Hearing Officer's Report and Recommendations

Enviva Pellets Northampton, LLC Public Hearing
Monday, May 24, 2021 6:00 PM
Online Meeting via Webex

Pertaining to Application No. 6600167.20A and
Draft Air Permit No. 10203T08 for:

Enviva Pellets Northampton, LLC
309 Enviva Boulevard
Garysburg, Northampton County, North Carolina
Facility ID No. 6600167
Fee Class: Title V
PSD Class: Major

Depiction of a two can RTO system

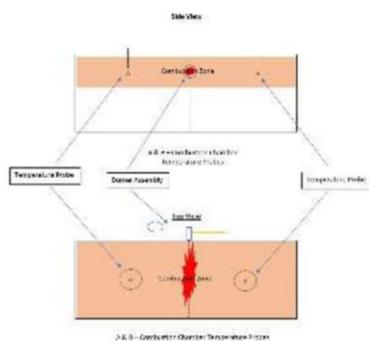
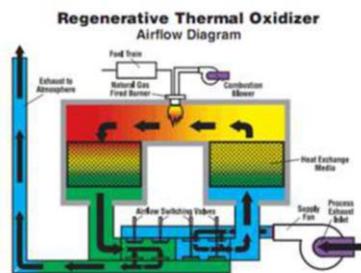
2. Removal of Language Requiring Temperature Monitoring in the Second Half of the Oxidizer Away from the Flame Zone.

Condition 2.2 A.2.f of the draft permit requires Enviva to monitor the temperature in the combustion chamber “(the second half of the oxidizer away from the flame zone)” of the RTOs and RTO/RCO. This language is not consistent with the equipment configuration as specified by the vendor design specifications. Furthermore, this language contradicts Condition 2.2 A.2.d.vi, of the draft permit which accurately reflects the location of the thermocouples. As described in Condition 2.2 A.2.d.vi, the RTOs and RTO/RCO are each comprised of multiple fireboxes, with each firebox containing two temperature

probes. The minimum average firebox temperature for each firebox is based on the average temperature of the two temperature probes over the span of the compliance test runs. As such, Enviva requests that the language requiring monitoring in “the second half of the oxidizer away from the flame zone” be removed from Condition 2.2 A.2.f.

For reference, the diagram below illustrates the location of the two thermocouples in a two (2) can RTO (i.e., firebox) per the vendor design specifications. Note, air flows through to the burner flame (from can A to can B or can B to can A) always crossing through the path of the burner flame before exiting the RTO.

Regarding item one above, the facility was contacted via telephone from the DAQ permitting section to further discuss this comment, the permit remains unchanged. Regarding item two above, the facility requested that the language requiring monitoring in "the second half of the

oxidizer away from the flame zone” be removed from Condition 2.2 A.2.f. Regarding item three above, visible emission observations remain weekly and only can be less frequent after demonstrating consistent compliance. Item four above, correcting a typo for the numbering of Section 2.1.A.1.h will be corrected. Item five above, under Condition 2.1.A.3.d, the facility requested changing the 30-day requirement to 180 days, however the language will be changed to "at the first idle bypass mode after the effective date of this permit or beginning of operation." Item six above requests modified language for clarity of Condition 2.1.A.2.c.; the language will be modified for clarity. Item seven above requests modified language for clarity of Condition 2.2.A.2.n; the language will be modified for clarity.

Recommendation: It is recommended that language requiring monitoring in “the second half of the oxidizer away from the flame zone” be removed from Condition 2.2 A.2.f. Also recommended is correcting a typo for the numbering of Section 2.1.A.1.h. It is also recommended under Condition 2.1.A.3.d changing the 30-day requirement to "at the first idle bypass mode after the effective date of this permit or beginning of operation." Item six above suggests clarified language to Condition 2.1.A.2.c, it is recommended the draft permit condition be modified to reflect this clarified language. Item seven above suggests clarified language to Condition 2.2.A.2.n, it is recommended the draft permit condition be modified to reflect this clarified language.
